Re: Proposed Gateway Pacific Terminal Project

The City of Mount Vernon ("the City") is closely following the Gateway Pacific Terminal (GPT) Project proposed by Pacific International Terminals, Inc., through SSA Marine which includes the development of a multi-user import and export marina terminal for bulk, break-bulk, and other marine cargoes and the Burlington Northern Santa Fe (BNSF) Railway's Custer Spur Rail Expansion project ("the GPT Project"). This letter is intended to serve as the City of Mount Vernon's scoping comments for the GPT Environmental Impact Statement and is submitted to you on behalf of the Mayor of the City of Mount Vernon and the Mount Vernon City Council.

Based on the aforementioned concerns, the City respectfully requests that the EIS carefully consider in its scope the regional impacts of this proposal beyond Whatcom County including impacts to the City of Mount Vernon. As part of the analysis, the City believes full consideration of alternatives as well as mitigation measures designed to alleviate the conflicts between rail traffic and our system of roadways are in order.

Exhibit A

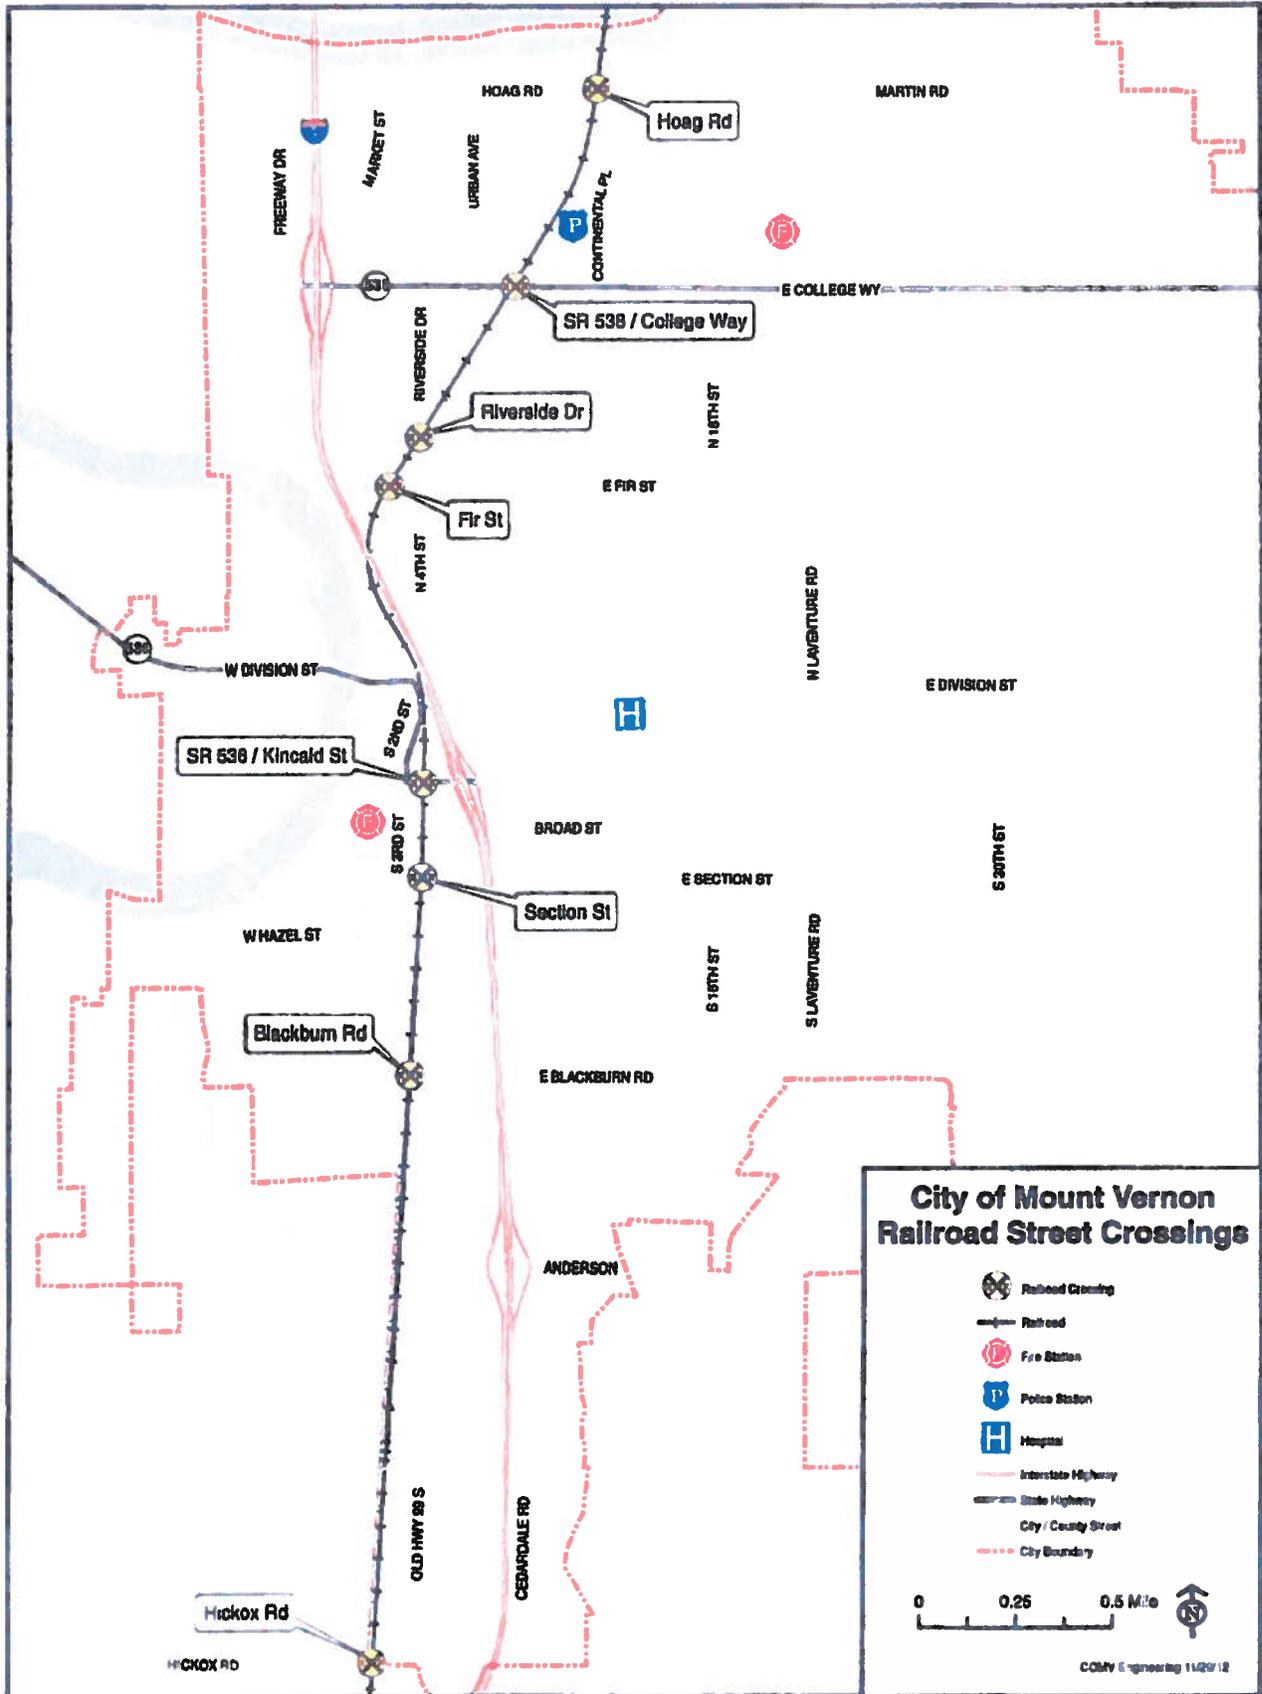
The City contains within its jurisdictional boundaries the BNSF rail line. This rail line has eight at-grade railroad crossings located within the City (two of which cross heavily traveled state routes; **Exhibit A**), one just east of College Way and Riverside Drive, the busiest intersection in the County, and another at Kincaid Street which is at the entrance to Mount Vernon's historic downtown and the location of the County Courthouse, Jail and City Hall. As explained below, it is expected this rail line, including at-grade crossings, will be utilized to serve the Project.

- *Please refer to Exhibit A for all at grade crossings to be examined for impacts and mitigation.*
